Product Update:

**SURELOK® Ride Height Lock
Mechanism**

LIT NO: P36013

DATE: October 2015

SURELOK Parts Changes:

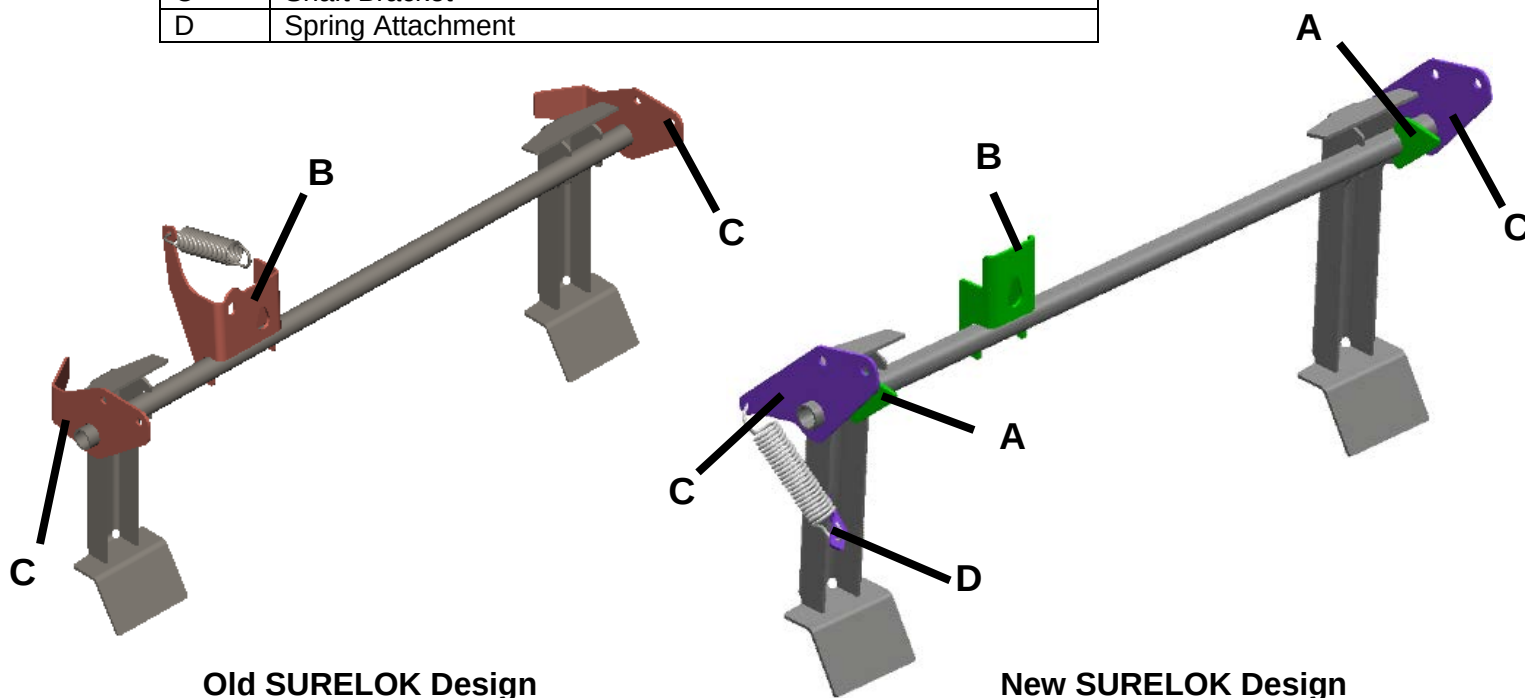
Hendrickson Trailer Commercial Vehicle Systems announces changes to SURELOK® Dock Solution parts on all VANTRAAX® integrated suspension system. With shipments beginning mid-November 2015 all SURELOK assemblies will feature several re-designed components. Please refer to the diagram below. The parts listed will change in appearance; the changes do not affect the function of the system.

A	New down-stop (removed current stop bolt - not shown)
B	Actuator Bracket
C	Shaft Bracket
D	Spring Attachment

Old SURELOK Design

New SURELOK Design

When replacing shaft bracket components on old SURELOK designs, part numbers will change from C-24453-1 and C-24453-2 to B-36137; the fit and function will remain the same. Please note: the old shaft bracket part numbers (C24453-1 and -2) are not compatible with the new SURELOK ride height lock assembly design.
